Product Safety Recall

N202322231 Seat Belt May Not Be Properly Attached

Release Date: January 2021

Revision: 01

5148395

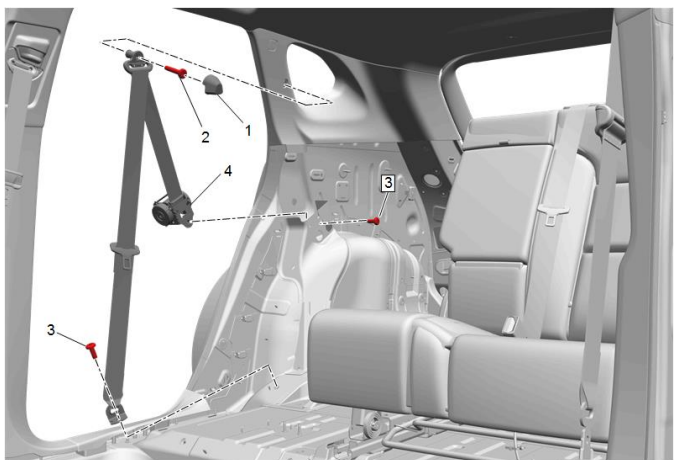
1. Remove the center pillar lower trim panel. It is not necessary to disconnect the seat belt from any location. Refer to *Center Pillar Lower Trim Panel Replacement* in SI.

2. Remove and discard the lower retractor bolt (2).
3. Install the new retractor mounting bolt. Refer to the note above for installation details. Tighten the new service bolt to 45 N.m (33 lb. ft).
4. Reinstall the center pillar lower trim panel. Refer to *Center Pillar Lower Trim Panel Replacement* in SI.

5142571

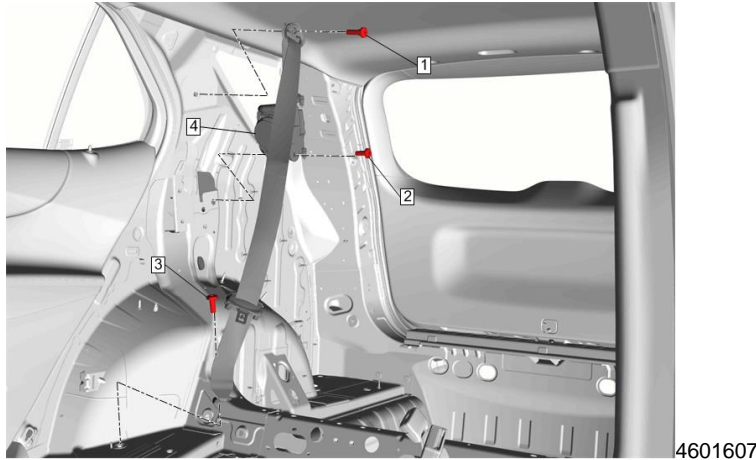
2. Remove the second-row seat belt retractor bolt (3) and seat belt anchor bolts (3). Discard the bolts.
3. Install **TWO** new bolts, one at the seat belt retractor and the second at the seat belt anchor bracket. Refer to the note above for installation details. Tighten the new service bolts to 45 N.m (33 lb. ft).
